RE: Cork City Council - Review of Waste Licence No. W0012-03 for Kinsale Road Landfill - Waste Transfer Station

This response is in relation to an application for a waste licence review (Licence Reference No. W0012-03) to include a waste transfer station at Kinsale Road Landfill, Ballyphehane, Curraghconway, Inchisarsfield, South City Link Road, Cork. The following documentation has been included:

**FURTHER INFORMATION REQUEST
ON WASTE LICENCE REVIEW AT KINSALE ROAD
LANDFILL - LICENCE REGISTER NO. W0012-03**

Title of Drawing
LOCATION OF INTERCEPTORS / SILT TRAPS

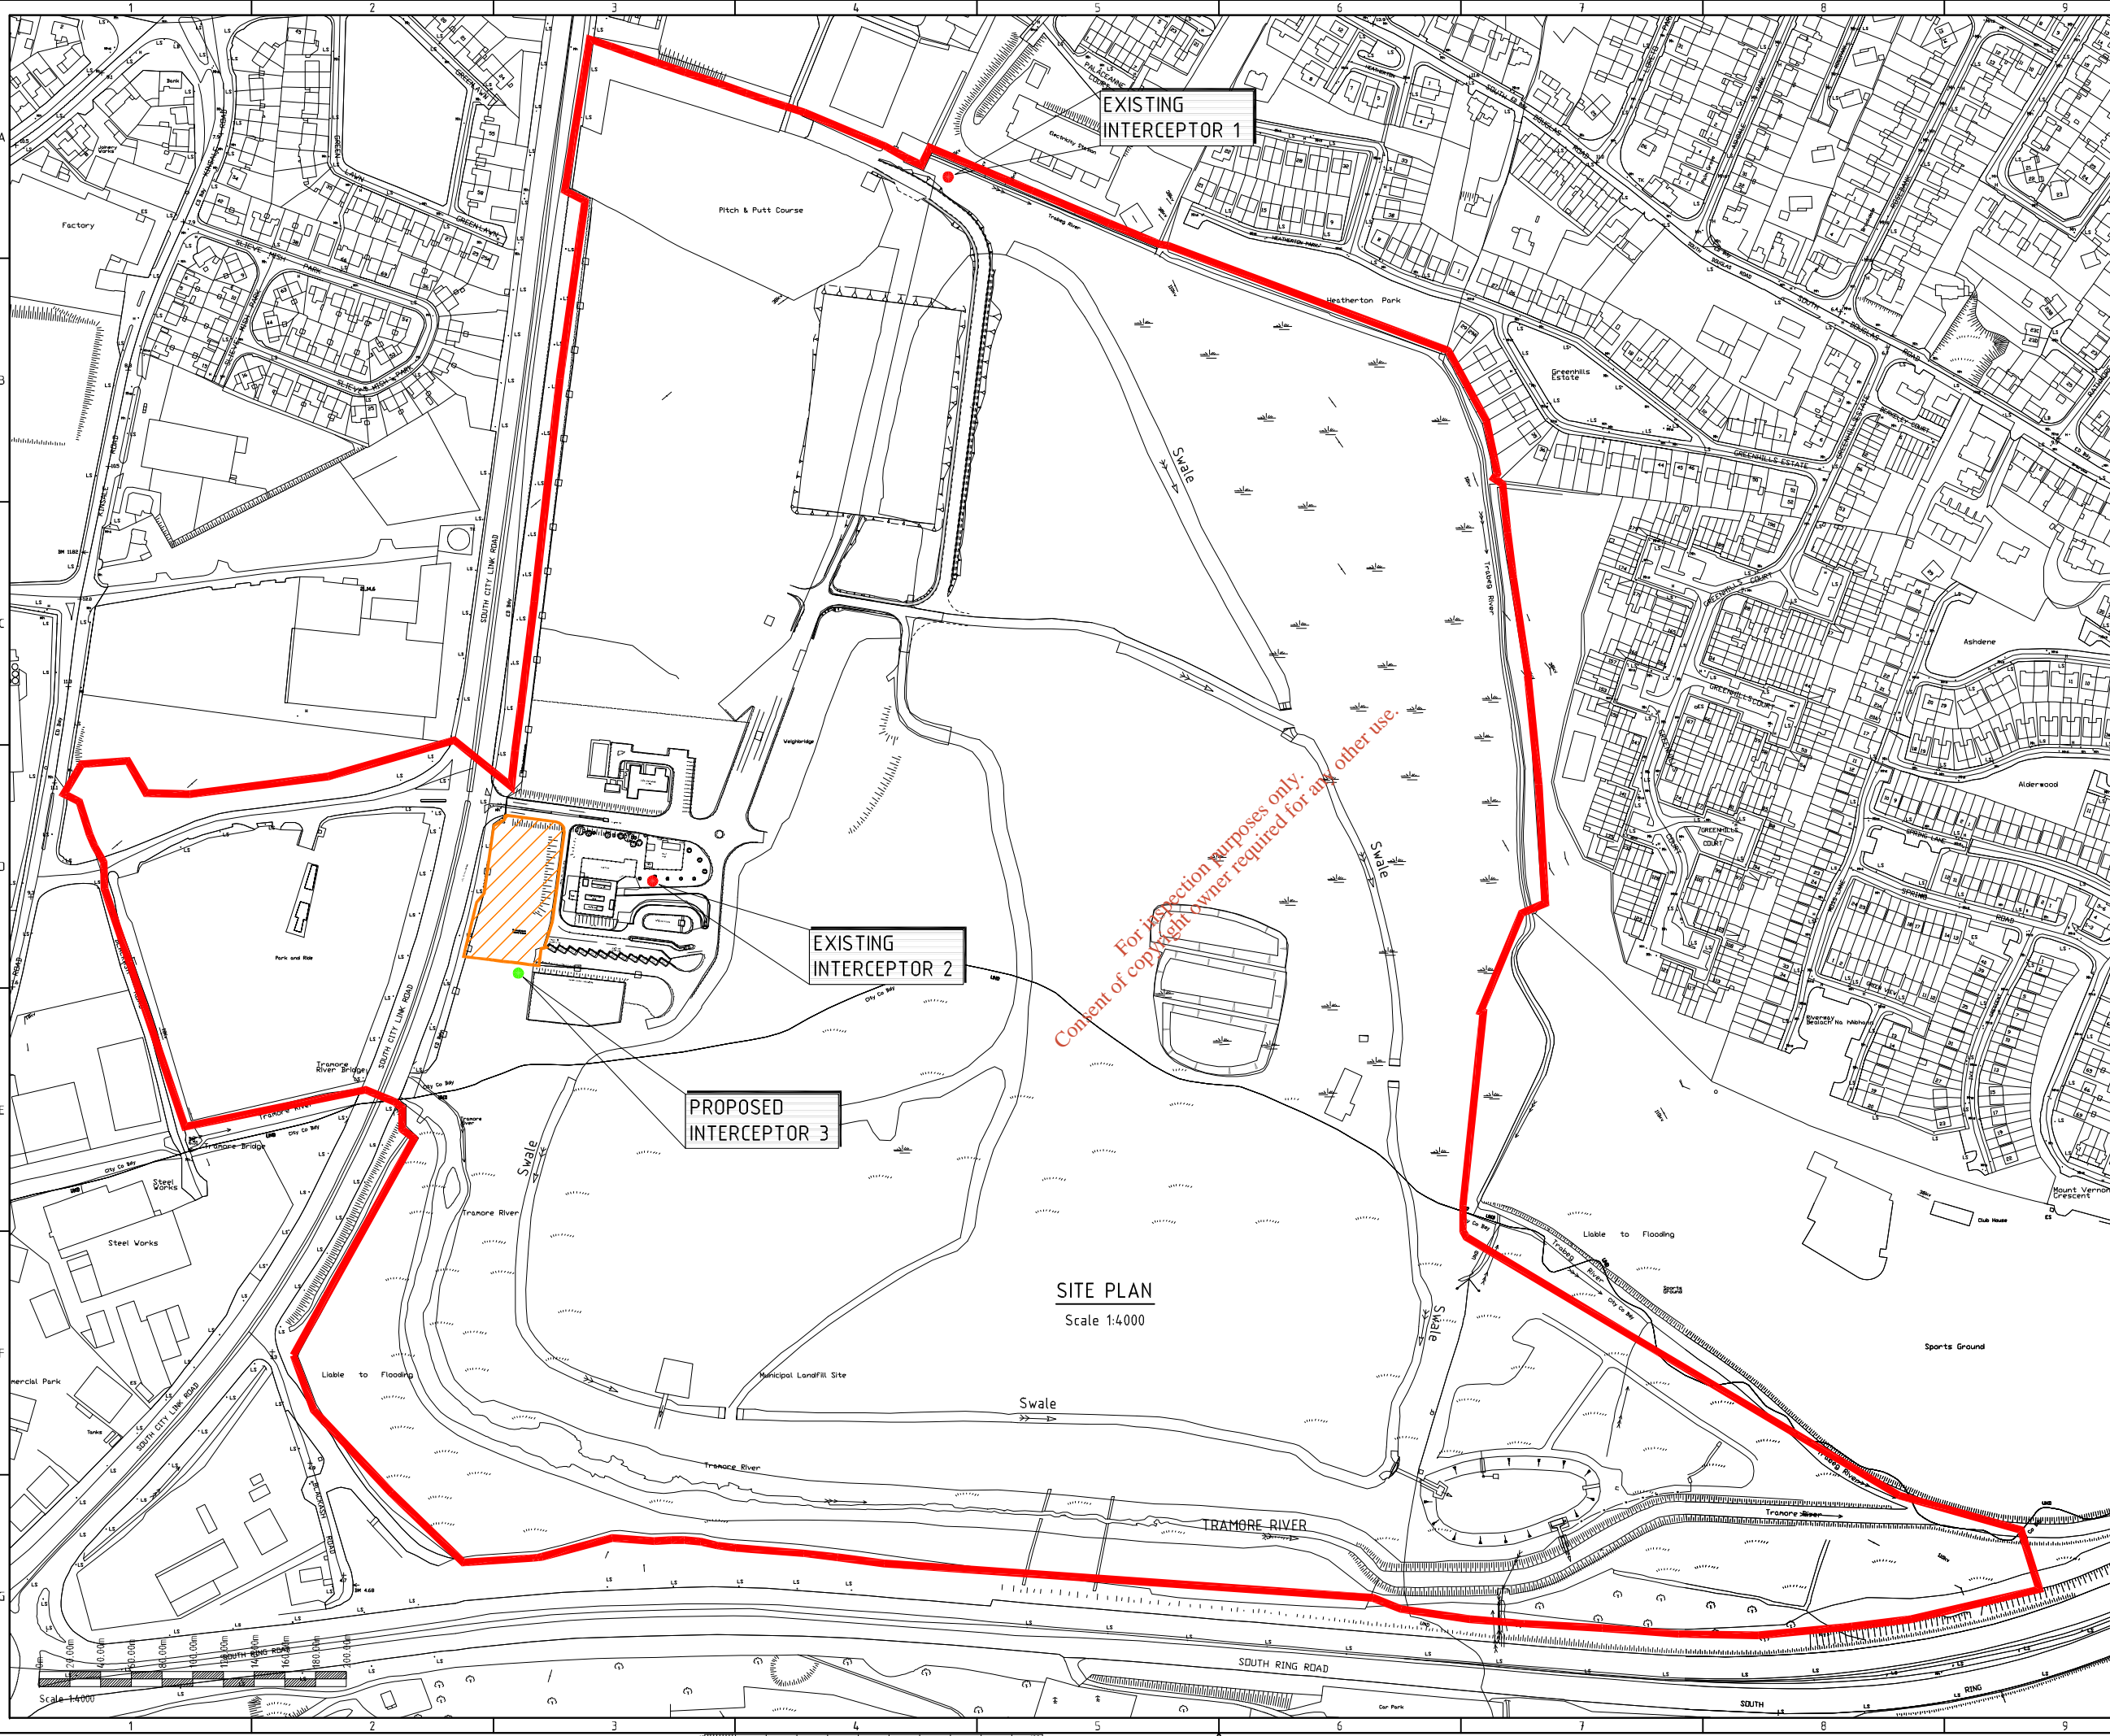
6. Clarify the class, specification and location of all existing and proposed interceptors and silt traps.
7. Identify the location of the on-site wheel wash on a suitably scaled map.

interceptors is outlined on Drawing LW0900103-001 A in Appendix 4.

As part of the waste transfer station, a silt trap/interceptor is proposed. Run-off from within the waste transfer station building will be discharged through this interceptor to the leachate treatment plant before being discharged to the Tramore Valley sewer. As the wastewater is being discharged to a sewer and not directly to surface water, a Klargestor Class II Bypass Separator NSB 3 or similar will be a sufficient specification in this location. The proposed interceptor location is also included in Drawing LW0900103-001 A in Appendix 4.
